1570-1580 CANTERBURY RD, PUNCHBOWL NSW 2196
LOT 54 / DP12280 & LOT 2 DP589284

MIXED-USE DEVELOPMENT ACROSS THREE TOWERS (PART CLASS 2 & PART CLASS 5) WITH SHARED BASEMENT PARKING (CLASS 7A)

MODIFICATION APPLICATION UNDER S.455(2) OF THE EP&A ACT

TOTAL OF 58 RESIDENTIAL APARTMENTS AND 2 GROUND FLOOR COMMERCIAL TENANCIES,
WITH BASEMENT CARPARKING FOR 88 VEHICLES ACCESSED VIA
RIGHT OF WAY OVER 17 WEYLAND STREET

DRAWING NO.
A0104

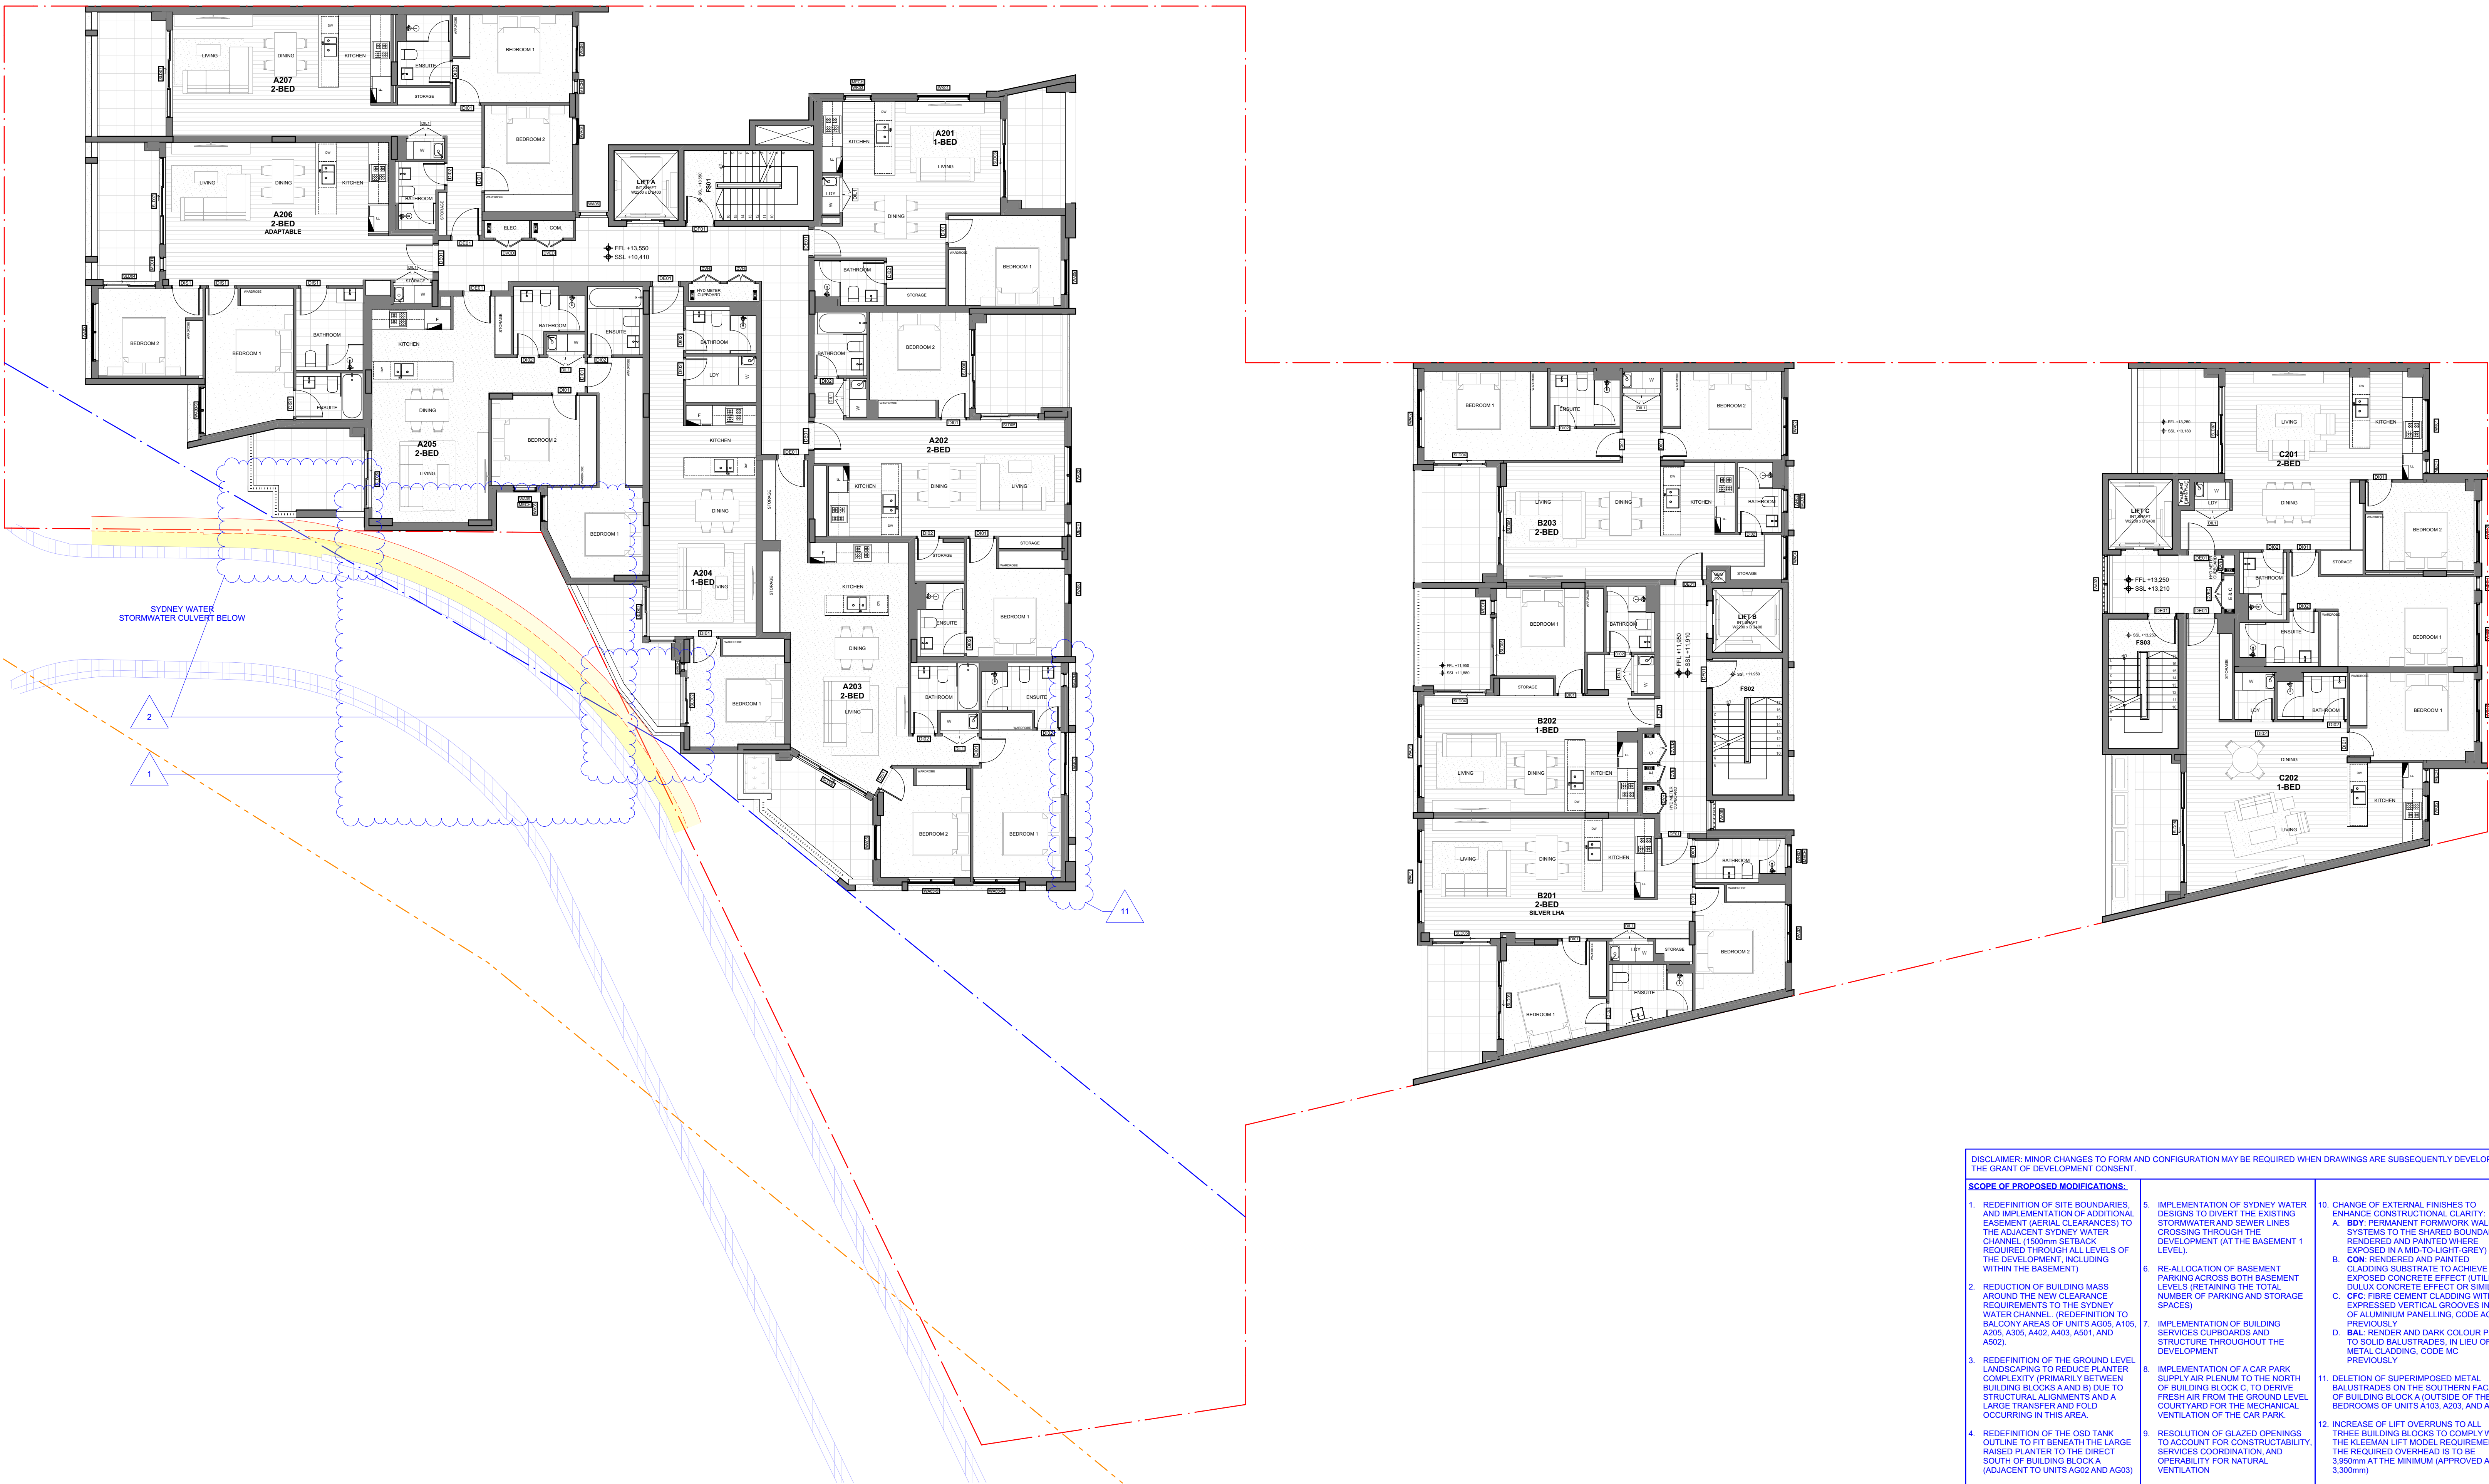
1. REDEFINITION OF SITE BOUNDARIES, AND IMPLEMENTATION OF ADDITIONAL EASEMENT (AERIAL CLEARANCES) TO THE ADJACENT SYDNEY WATER CHANNEL (150mm SETBACK REQUIRED THROUGHOUT ALL LEVELS OF THE DEVELOPMENT).	5. IMPLEMENTATION OF SYDNEY WATER DESIGNS TO DIVERT THE EXISTING STORMWATER AND SEWER LINES CROSSING THROUGH THE DEVELOPMENT (AT THE BASEMENT 1 LEVEL).	10. CHANGE OF EXTERNAL FINISHES TO ENHANCE CONSTRUCTIONAL CLARITY: A. BOY PERMANENT FORMWORK WALLS SYSTEMS TO THE SHARED BOUNDARIES, RENDERED AND PAINTED WHERE EXPOSED IN A MID-TO-LIGHT-GREY. B. CON: RENDERED AND PAINTED CLADDING SUBSTRATE TO ACHIEVE AN EXPOSED CONCRETE EFFECT (UTILISING DUXUS CONCRETE EFFECT OR SIMILAR). C. CPC: FIBRE CEMENT CLADDING WITH EXPRESSED VERTICAL GROOVES IN LIEU OF ALUMINIUM PANELING, CODE AC1 PREVIOUSLY. D. BAL: RENDER AND DARK COLOUR PAINT TO SOLID BALUSTRADES, IN LIEU OF METAL CLADDING, CODE MC PREVIOUSLY.	13. IMPLEMENTATION OF THE BIN STORAGE ROOM SPATIAL REQUIREMENTS AS PER DA CONDITIONS: 40-43.

3. REDEFINITION OF THE GROUND LEVEL LANDSCAPING TO REDUCE PLANTER COMPLEXITY (PRIMARILY BETWEEN BUILDING BLOCKS A AND B) DUE TO STRUCTURAL ALIGNMENTS AND A LARGE TRANSFER AND FOLD OCCURRING IN THIS AREA.	7. IMPLEMENTATION OF BUILDING SERVICES CURBWAYS AND STRUCTURE THROUGHOUT THE DEVELOPMENT.	12. INCREASE OF LIFT OVERRUNS TO ALL THREE BUILDING BLOCKS TO COMPLY WITH THE KLEEMAN LIFT MODEL REQUIREMENTS. THE REQUIRED OVERHEAD IS TO BE 3,300mm AT THE MINIMUM (APPROVED AS 3,300mm).	15. CHANGE OF FIRE EGRESS PATHS TO THE GROUND LEVEL EXITS FOR THE SOUTHERN BASEMENT FIRE STAIRCASE TO IMPROVE COMPLIANCE WITH THE NCC AND AVOID DIFFICULTIES WITH THE FIRE BRIGADE.

4. REDEFINITION OF THE OSD TANK OUTLINE TO FIT BENEATH THE LARGE RAISED PLANTER TO THE DIRECT SOUTH OF BUILDING BLOCK A (ADJACENT TO UNITS A202 AND A203).	8. IMPLEMENTATION OF A CAR PARK SUPPLY AIR PLENUM TO THE NORTH OF BUILDING BLOCK C, TO DERIVE FRESH AIR FROM THE GROUND LEVEL COURTYARD FOR THE MECHANICAL VENTILATION OF THE CAR PARK.	16. CHANGE OF THE CANTERBURY ROAD PEDESTRIAN ENTRY TO A GATED ENTRY AS PER SYDNEY WATER MAINTENANCE ACCESS REQUIREMENTS. THE SECURE LIFT LOBBY HAS BEEN BROUGHT BACK TO THE LIFT FOYER LINE.

REVISION NO. A
DRAWING NO. A0105

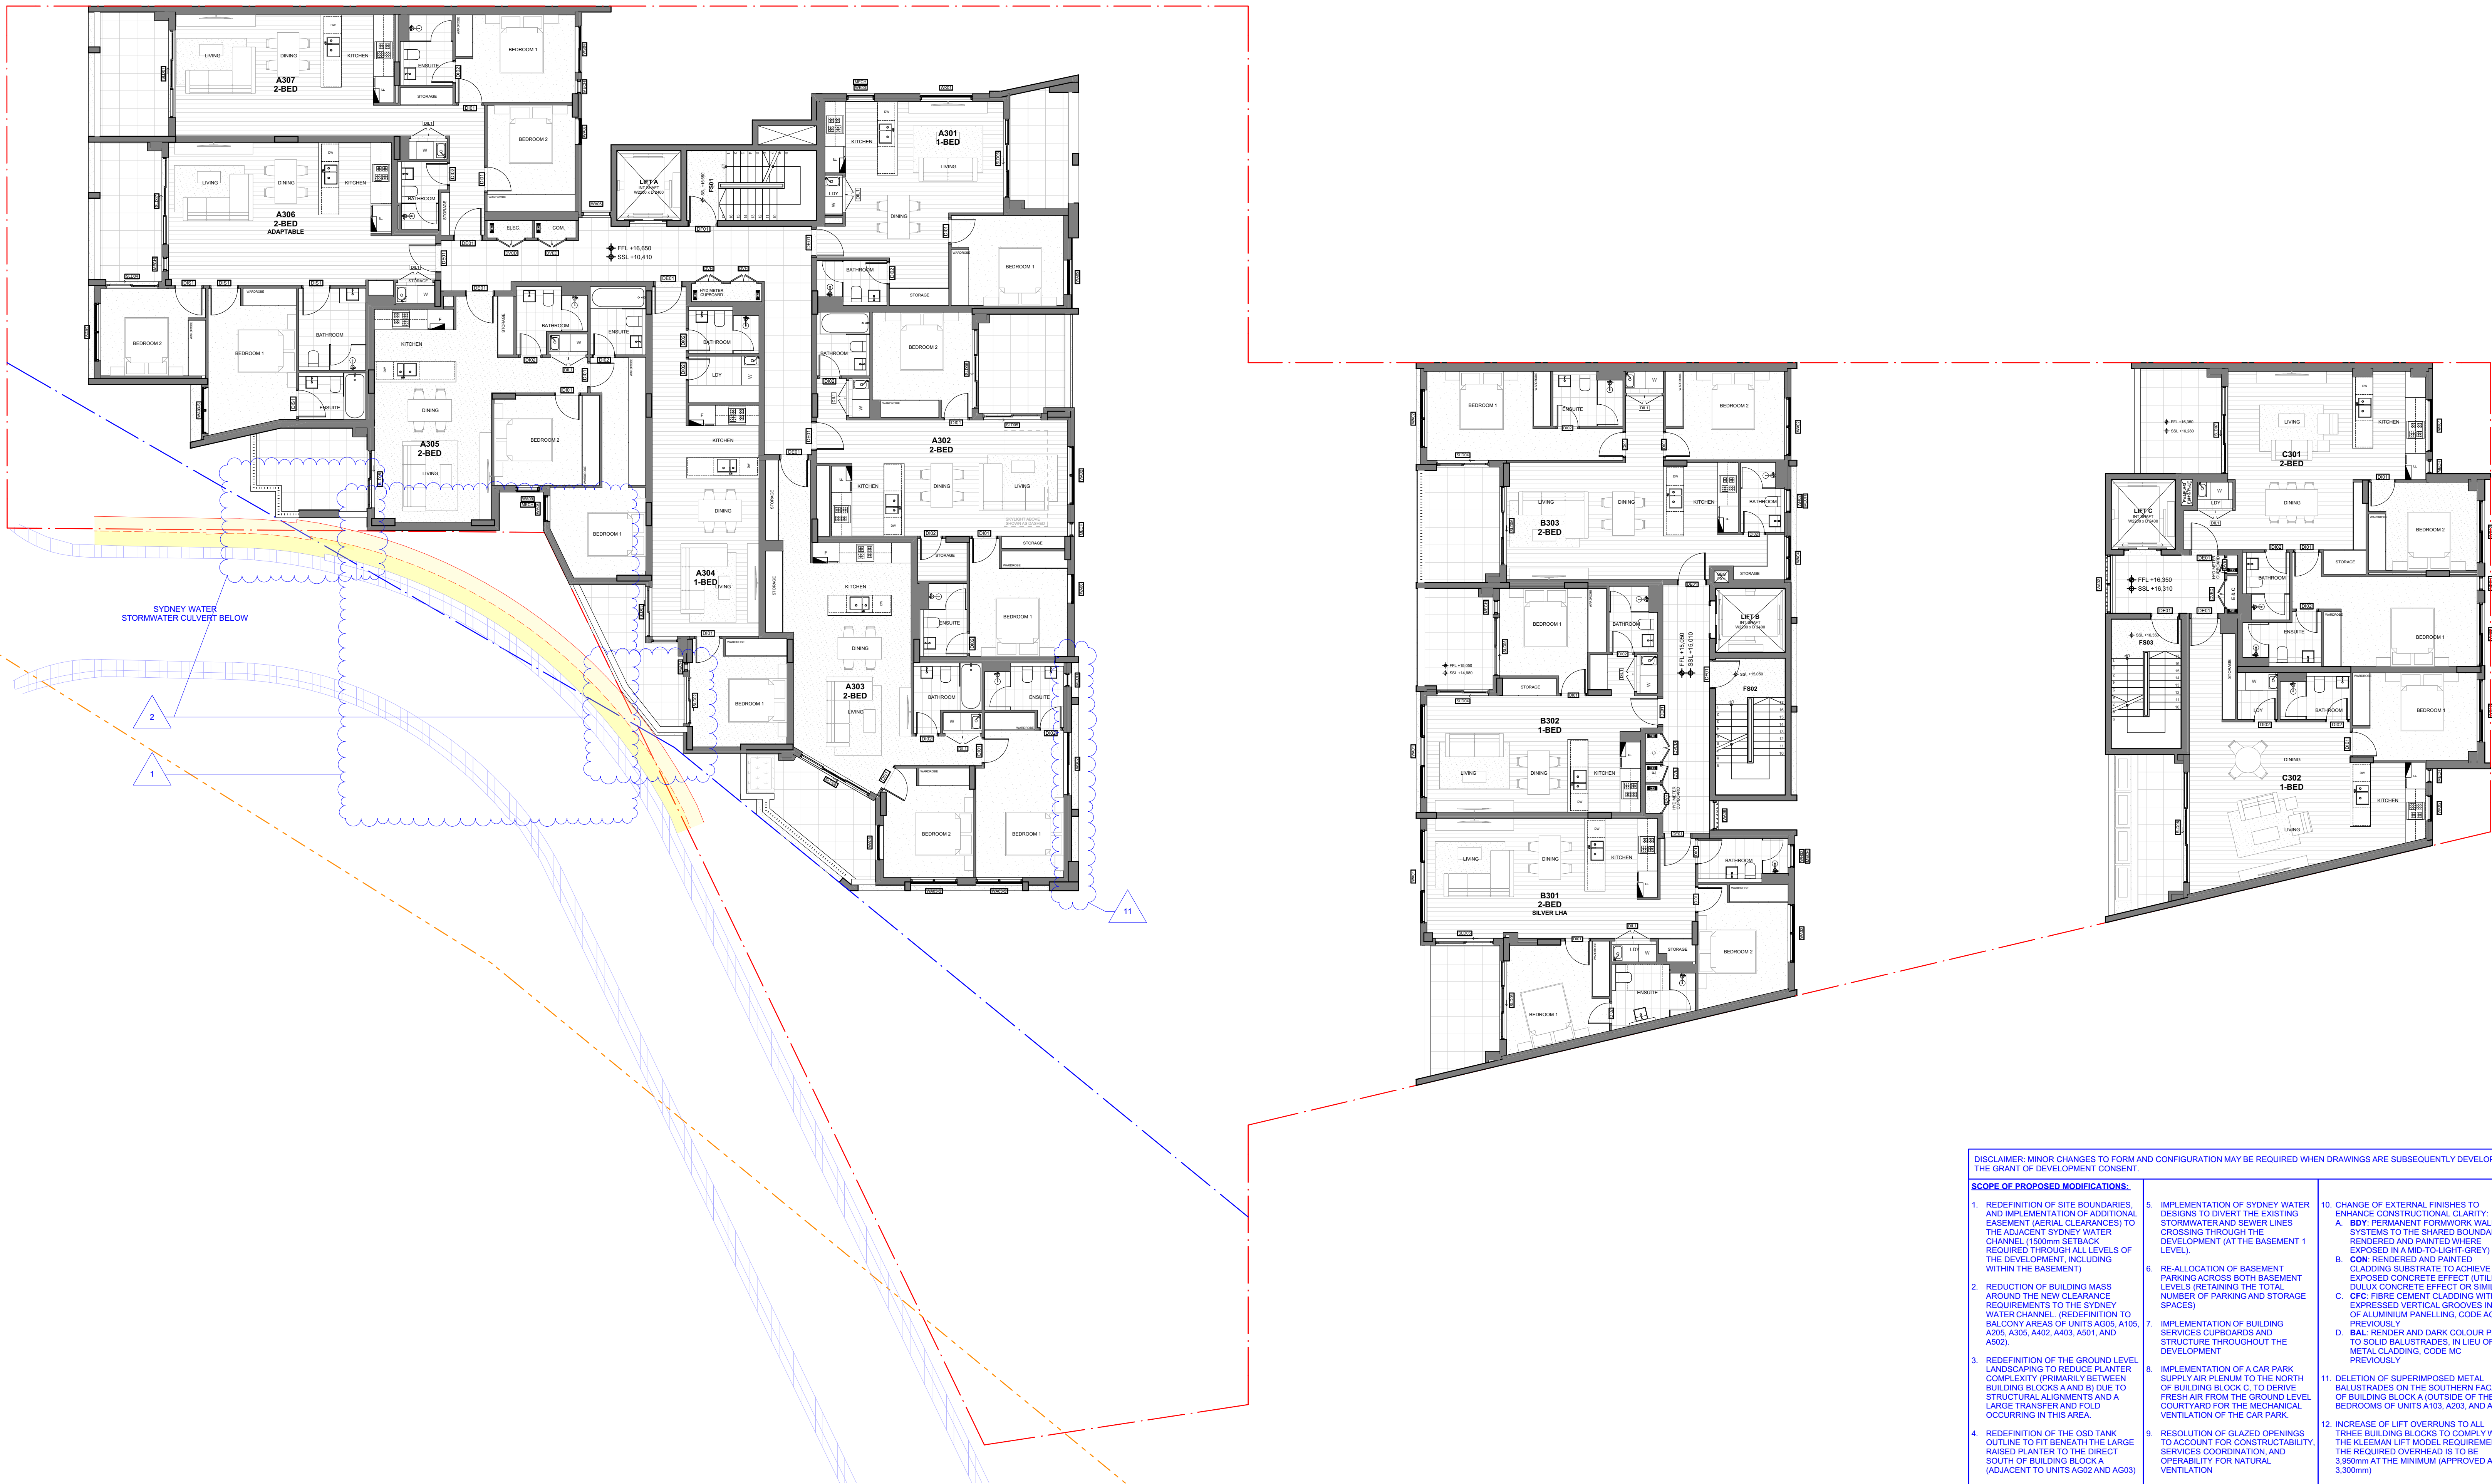
1. REDEFINITION OF SITE BOUNDARIES, AND IMPLEMENTATION OF ADDITIONAL EASEMENT (AERIAL CLEARANCES) TO THE ADJACENT SYDNEY WATER CHANNEL (150mm SETBACK REQUIRED THROUGHOUT ALL LEVELS OF THE DEVELOPMENT).	5. IMPLEMENTATION OF SYDNEY WATER DESIGNS TO DIVERT THE EXISTING STORMWATER AND SEWER LINES CROSSING THROUGH THE DEVELOPMENT (AT THE BASEMENT 1 LEVEL).	10. CHANGE OF EXTERNAL FINISHES TO ENHANCE CONSTRUCTIONAL CLARITY: A. BOY PERMANENT FORMWORK WALLS SYSTEMS TO THE SHARED BOUNDARIES, RENDERED AND PAINTED WHERE EXPOSED IN A MID-TO-LIGHT-GRAY. B. CON: RENDERED AND PAINTED CLADDING SUBSTRATE TO ACHIEVE AN EXPOSED CONCRETE EFFECT (UTILISING DUXUS CONCRETE EFFECT OR SIMILAR). C. CPC: FIBRE CEMENT CLADDING WITH EXPRESSED VERTICAL GROOVES IN LIEU OF ALUMINIUM PANELING, CODE AC1 D. BAL: RENDER AND DARK COLOUR PAINT TO SOLID BALUSTRADES, IN LIEU OF METAL CLADDING, CODE MC PREVIOUSLY	13. IMPLEMENTATION OF THE BIN STORAGE ROOM SPATIAL REQUIREMENTS AS PER DA CONDITIONS: 40-43.

3. REDEFINITION OF THE GROUND LEVEL LANDSCAPING TO REDUCE PLANTER COMPLEXITY, PRIMARILY BETWEEN BUILDING BLOCKS A AND B DUE TO STRUCTURAL ALIGNMENTS AND A LARGE TRANSFER AND FOLD OCCURRING IN THIS AREA.	7. IMPLEMENTATION OF BUILDING SERVICES CURBWAYS AND STRUCTURE THROUGHOUT THE DEVELOPMENT	12. INCREASE OF LIFT OVERRUNS TO ALL THREE BUILDING BLOCKS TO COMPLY WITH THE KLEEMAN LIFT MODEL REQUIREMENTS. THE REQUIRED OVERHEAD IS TO BE 3,300mm AT THE MINIMUM (APPROVED AS 3,300mm)	15. CHANGE OF FIRE EGRESS PATHS TO THE GROUND LEVEL EXITS FOR THE SOUTHERN BASEMENT FIRE STAIRCASE TO IMPROVE COMPLIANCE WITH THE NCC AND AVOID DIFFICULTIES WITH THE FIRE BRIGADE.

4. REDEFINITION OF THE OSD TANK OUTLINE TO FIT BENEATH THE LARGE RAISED PLANTER TO THE DIRECT SOUTH OF BUILDING BLOCK A (ADJACENT TO UNITS A202 AND A303)	8. IMPLEMENTATION OF A CAR PARK SUPPLY AIR PLENUM TO THE NORTH OF BUILDING BLOCK C, TO DERIVE FRESH AIR FROM THE GROUND LEVEL COURTYARD FOR THE MECHANICAL VENTILATION OF THE CAR PARK.	16. CHANGE OF THE CANTERBURY ROAD PEDESTRIAN ENTRY TO A GATED ENTRY AS PER SYDNEY WATER MAINTENANCE ACCESS REQUIREMENTS. THE SECURE LIFT LOBBY HAS BEEN BROUGHT BACK TO THE LIFT FOYER LINE.
